APPENDIX A. RUNNING DESIGN CHANGES/FIELD SERVICE BULLETINS

The factory provided these ten Field Service Bulletins to 8X32 dealers and customers. Each Bulletin describes a remedial procedure for a specific problem, or a hardware change necessary to implement an improvement in the machine's design.

URSA MAJOR, Inc.

8X32 FIELD SERVICE BULLETIN #1

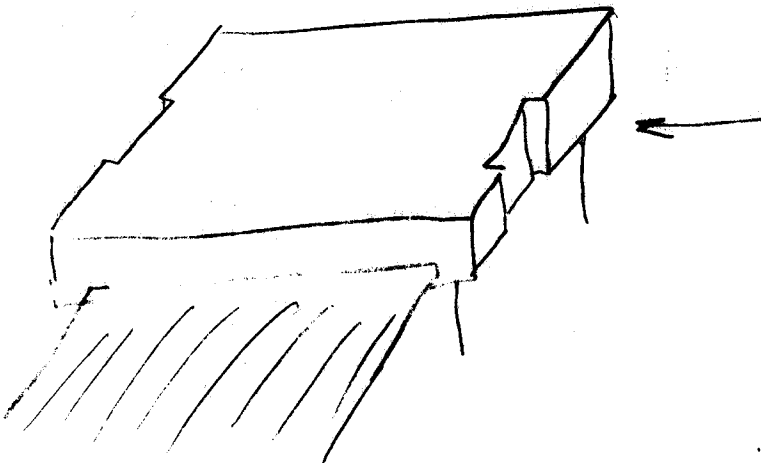
PROBLEM: J5 DIP connector from panel board to CPU board may vibrate loose in shipping, resulting in failure of front panel display or control functions.

HOW TO CORRECT THE PROBLEM: Unplug the unit from power. Set it right side up with front panel facing you. Protect the front panel with a soft cloth. Remove the top cover with the screws around the perimeter. Locate the ribbon cable at the front left of the unit and unplug the 24 Pin plug from J5 on the CPU-1 PC board. Gently bend it back, out of the way, toward the front of the unit and locate the tie wrap securing the large bundle of 6 wires passing underneath the cable, and cut the tie wrap securing these wires to the mother board. Redress that 6 wire group so that the wires are underneath the mother board and out of the way completely of the ribbon cable as it passes toward J5. Using a file, put 2 small notches (roughly 3/16" wide by 1/32" deep) 1 at each end of the plug that goes into J5. Attach the short piece of foam tape on top of the plug that goes into J5. Reinstall the plug into J5 and snap the new plastic clip down in place to secure the connector. Screw the cover back in place.

- 1.) 1 piece foam self stick tape, 1/2" x 3/4" x 1/8".
- 2.) 1 eby 24 Pin DIP clamp.

8X32 FIELD SERVICE BULLETIN #2

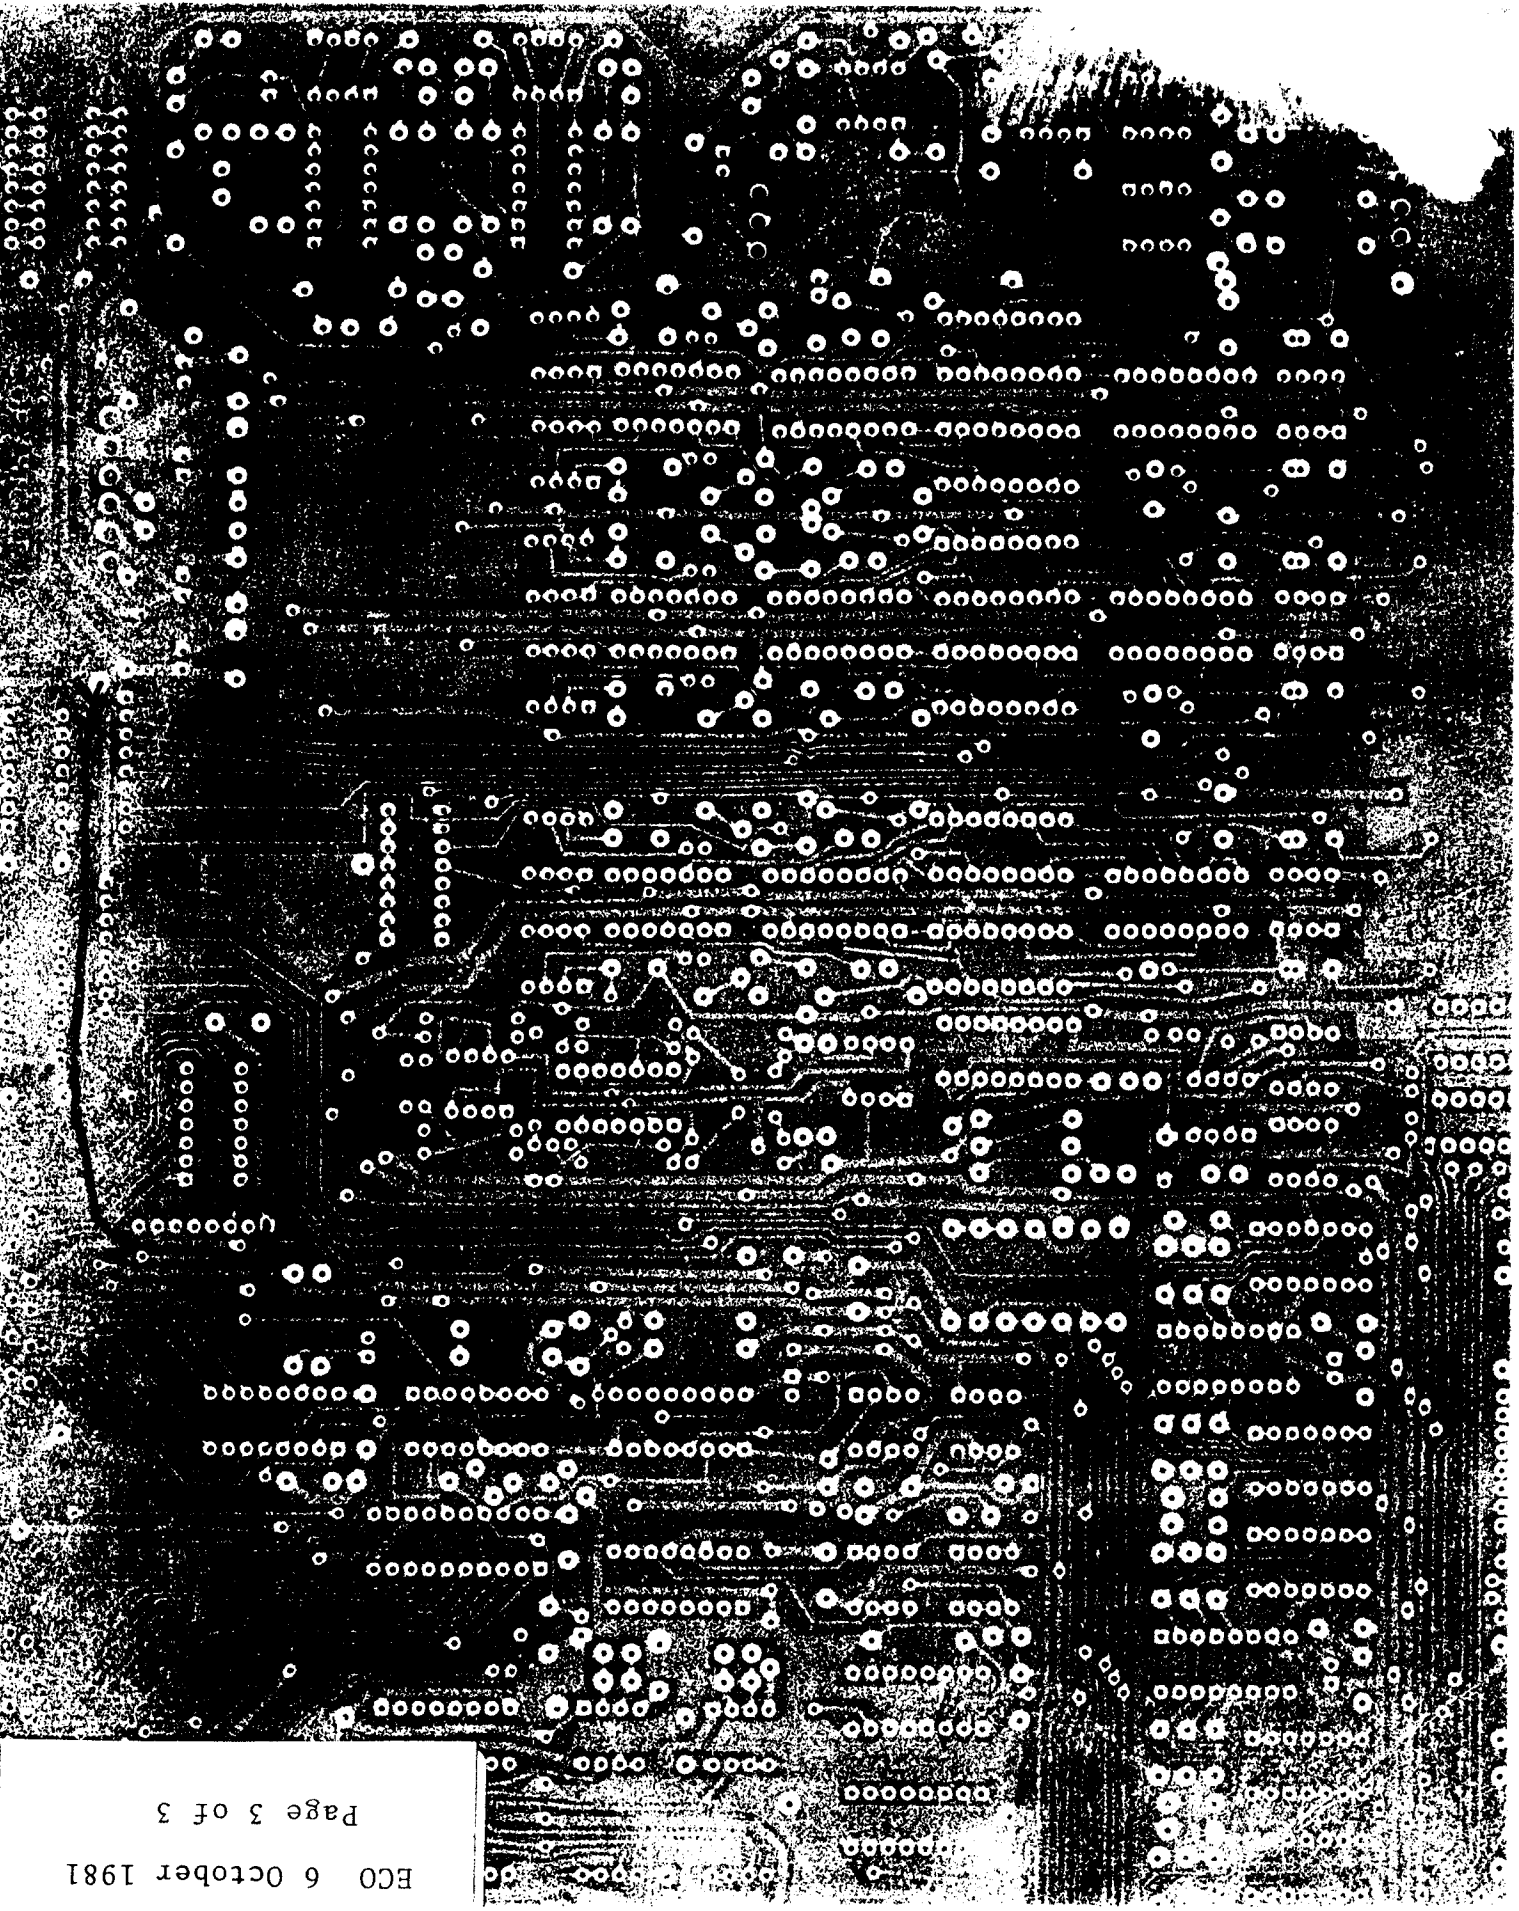
PROBLEM: SIP resistor network RN34 on ANA-2 PC board has its pin 1 connected in error to +5V. It should be connected to +7.5V. This may result in premature failure of IC's U2, U4, U5, and U6. These are Fairchild or Motorola MC14051B CMOS IC's.

The symptom would be improper operation of the early reflection level controls and/or initial reverberation level controls. Improper operation could take the form of the levels not changing equally in both channels, or not changing smoothly in monotonically increasing or decreasing steps. Another symptom could be pops or clicks as the level is nudged up or down.

HOW TO CORRECT THE PROBLEM: Disconnect the 8X32 from power. Turn it upside down, with the front panel facing you. Protect the front panel with a soft cloth. Remove the screws holding the bottom cover in place and set the bottom cover aside. Unplug the 2 input connectors, the connector from the potentiometer on the rear panel and connectors going to the output connectors on the front left side. Unsolder the 3 green wires, having made a note in advance where they were soldered. Remove five number 6-32 screws around the perimeter of the board. DO NOT remove the 2 screws at the very front edge of the board. Remove the 3 hexagonal standoffs. Carefully bend the wires out of the way at the left rear, and hinge the analog board upward. Locate resistor network RN34, near IC65 and, on the etch side of the board (the

solder side, the side without components), find Pin 1 (noted by a square pad) of RN34. With a sharp knife cut the edge going to Pin 1 of RN34. Referring to the attached diagram, run a small insulated wire from RN34, Pin 1 to the pad near RN36 Pin 1. Verify with an ohm meter that this RN34 Pin 1 is now connected to +7.5V and not to +5V. If the unit had developed a problem leading to carrying out this change, locate the defective IC U2, U4, U5 or U6 by normal trouble shooting techniques and replace as necessary.

8X32 FIELD SERVICE BULLETIN #4

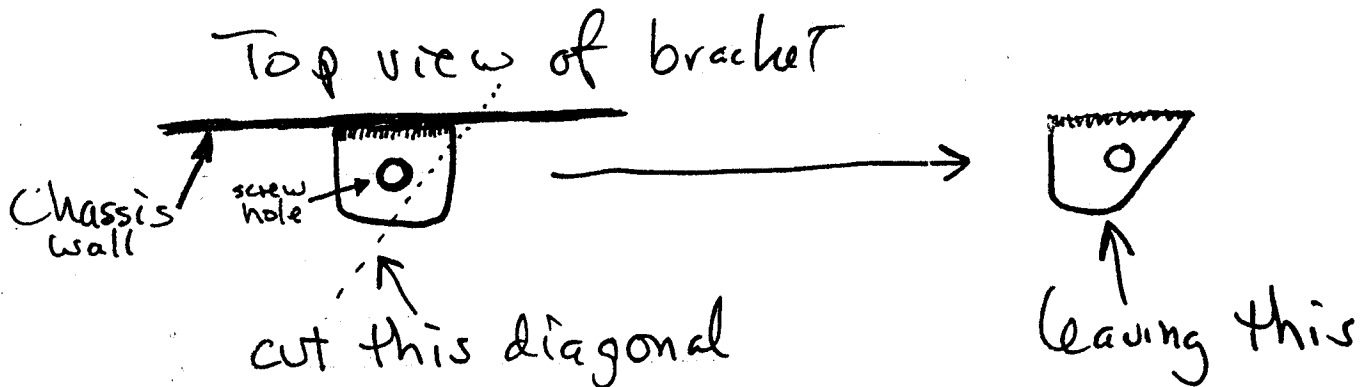
PROBLEM: The Keystone bracket which is mounted on chassis under H17 of ANA-2, sometimes makes contact with R13 of ANA-2.

HOW TO CORRECT THE PROBLEM: Remove AC power and then the bottom cover. Unsolder 3 green wires from connector on ANA. Remove all plug-in connectors from the ANA, except the 3 ribbon cables. Remove 3 standoffs and the perimeter screws, except for the two at the front edge of the ANA. Hinge the board up to reveal the bracket closest to R13. Refer to the figure and clip the bracket.

8X32 FIELD SERVICE BULLETIN #5

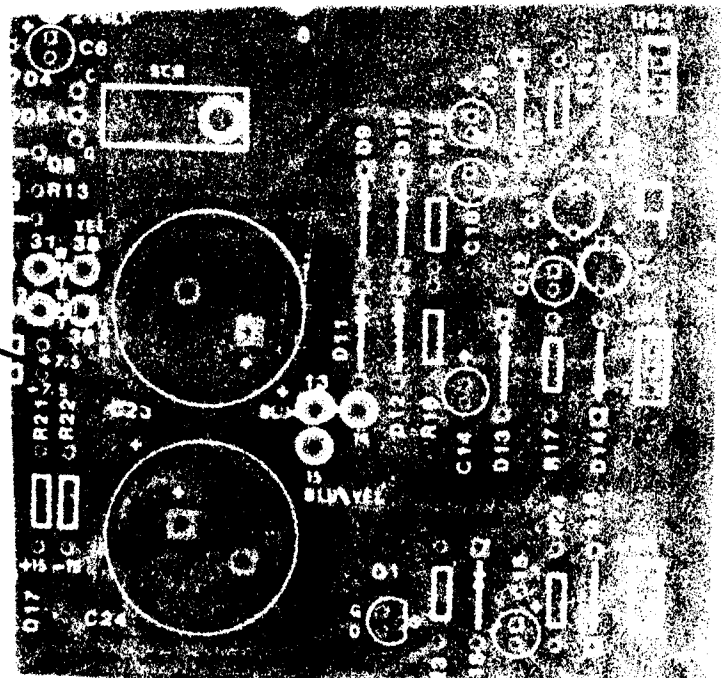
PROBLEM: Units hot to touch on chassis, right hand side. The extra heat is due to a wiring error where the blue-yellow and one of the blue wires were interchanged coming from the transformer secondary.

BLU-YEL wire should go here, in 15.

HOW TO CORRECT THE PROBLEM: Unplug the 8X32 from A/C line. Remove the top cover. Find the blue-yellow wire in the wrong hole. Unsolder the blue-yellow wire from the top side, applying heat to the joint and pulling the wire upward. Also remove the blue wire in hole 15. Reinsert the blue-yellow wire in hole 14 and resolder from the top.

FIGURE:

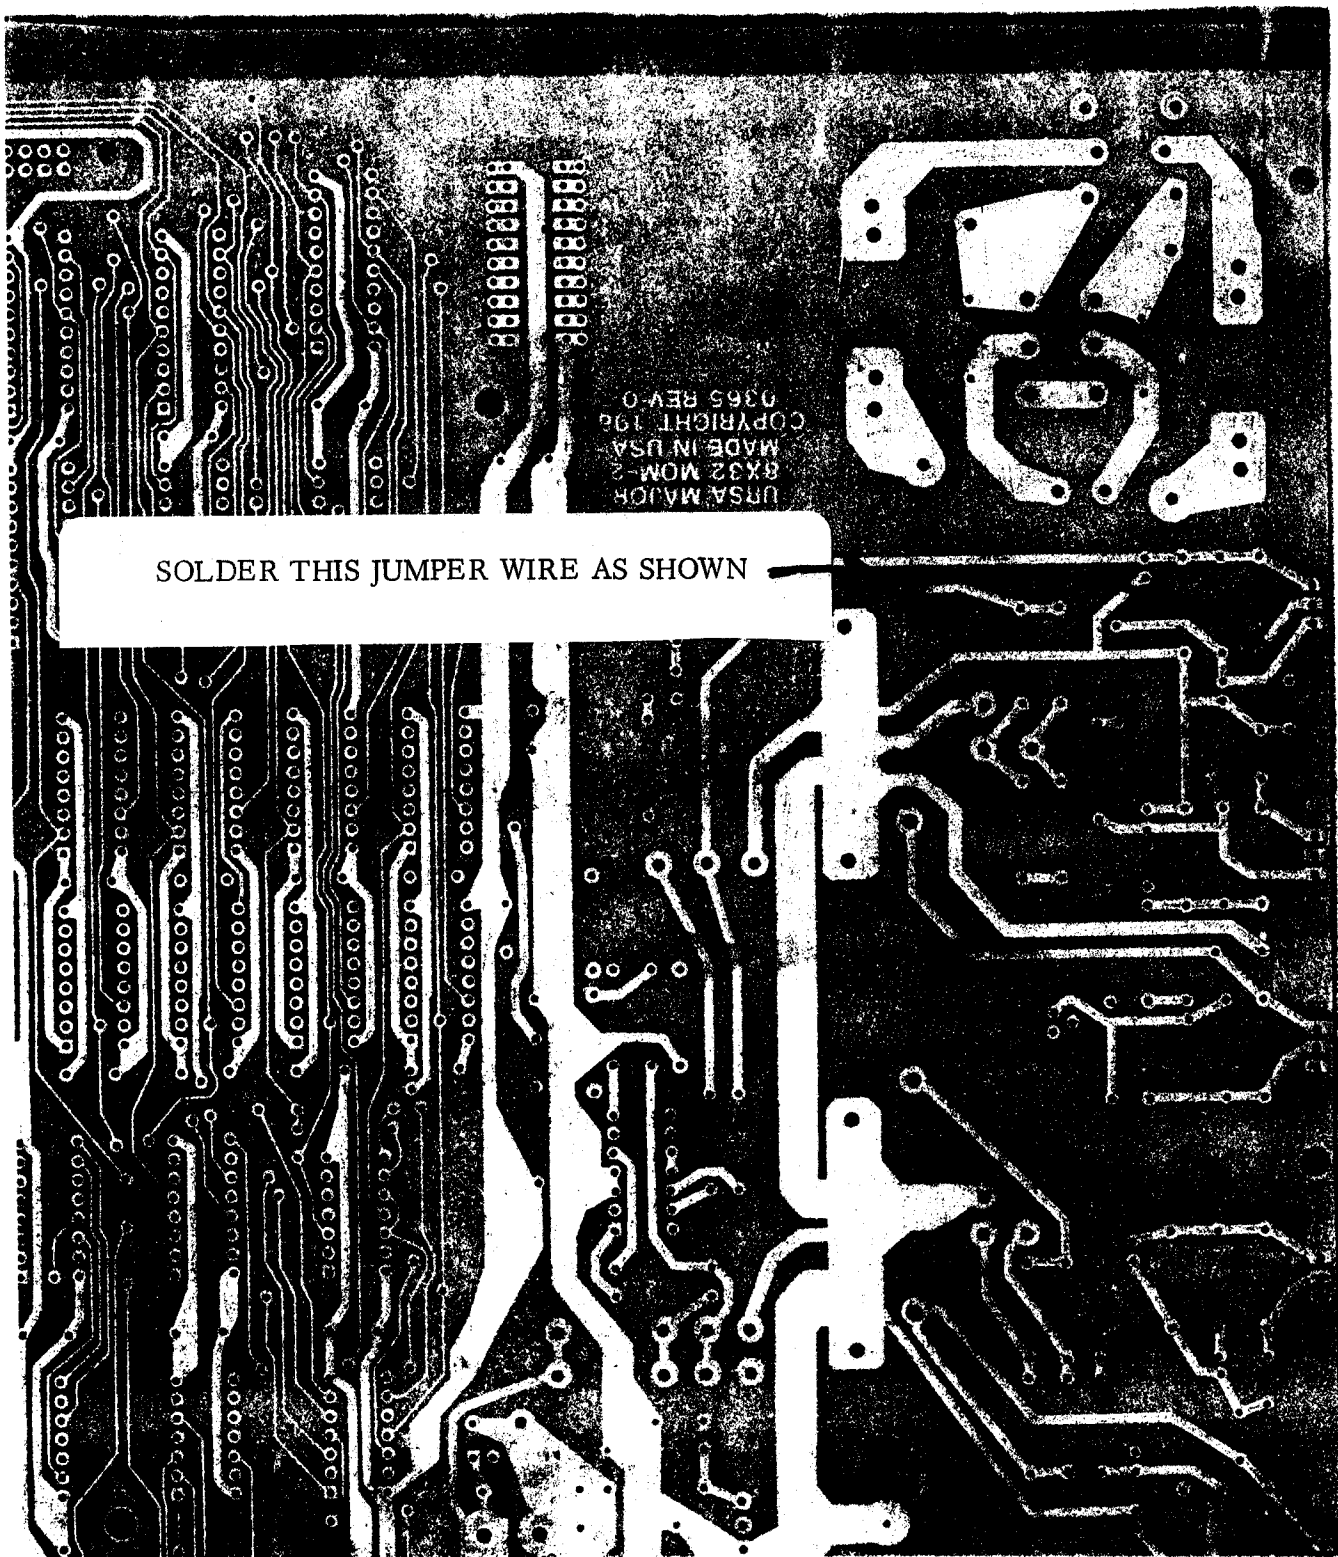
PROBLEM: The negative lead for capacitor C26 on the mother board (MOM) passes through a hole that is not plated through. Without the plating there is a slight chance that a connection does not exist or could become intermittent from the etch side of the PC board to the component side. In the event that this connection did become intermittent, the -15V power supply would drop to 0. This would result in failure of the audio and other functions of the 8X32.

HOW TO CORRECT PROBLEM: Remove the A/C line cord from the unit. Turn the 8X32 upside down and remove the bottom cover. Remove all the connectors going to the ANA board except the ribbon cables on the front edge. Unsolder the three green wires going to the connector on the ANA board. Remove the three hexagonal standoffs and all the small screws holding the ANA board down except the two at the front of the board. Swivel the analog board upware, revealing the underside of the MOM board, (the "etch side"). Locate C26 minus pad on the etch side of the board and D25 anode on the MOM board by observing from the component side. Solder a short piece of #22 insulated wire from C26 minus lead to D25 anode. Reassemble the unit. It would be wise to verify correct -15V power supply operation before completely reassembling the unit.

ETCH SIDE VIEW

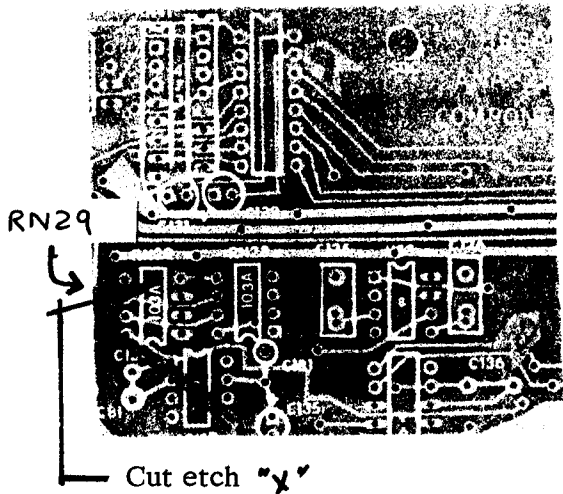
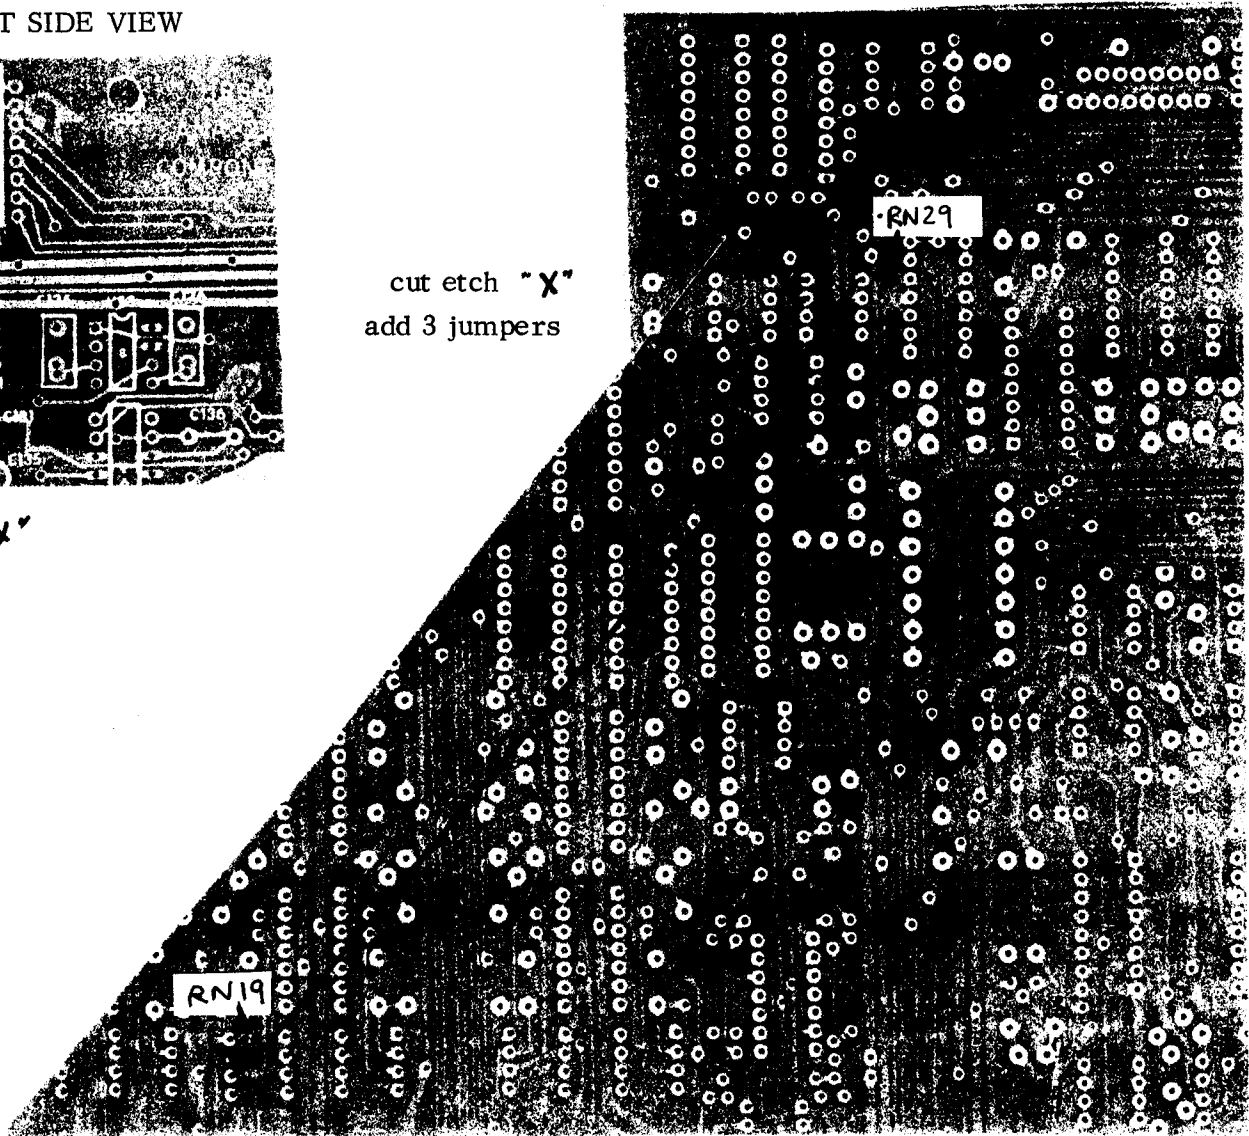
PROBLEM: In some units, the minor DC offsets inevitable associated with linear and A to D components, resulted in the A to D converter for the Ap signal resting with 0 signal at the decision point for mid scale, (the sign decision point). Normal circuit noise under these conditions will permit the build up of a hollow, reedy sounding noise in this converter which would appear at the output. This sounds sort of like a "buzz saw".

cut etch "X"
add 3 jumpers

If this is one of the six units in the field that has the correction partially carried out, only do the steps that follow. On the component side, locate RN29 and RN28. These are two resistor networks located near U68. On the component side observe a fine etch running between RN28, pin 5 and RN29, pin 4. With a sharp exacto knife, cut that etch. Now, on the component side, take a small piece of #30 solid wire and solder a connection between RN28, pin 5 and U68, pin 3 nearby.

Find a connection on the etch side from RN29, pin 4 to ground. Cut that connection. On the etch side, solder a short piece of wire from RN29, pin 4 to RN29, pin 3 (bare #30 wire is ok).

Using #30 insulated wire, connect RN29, pin 5 to RN19, pin 7 some distance away. Put the wire on the etch side of the board.
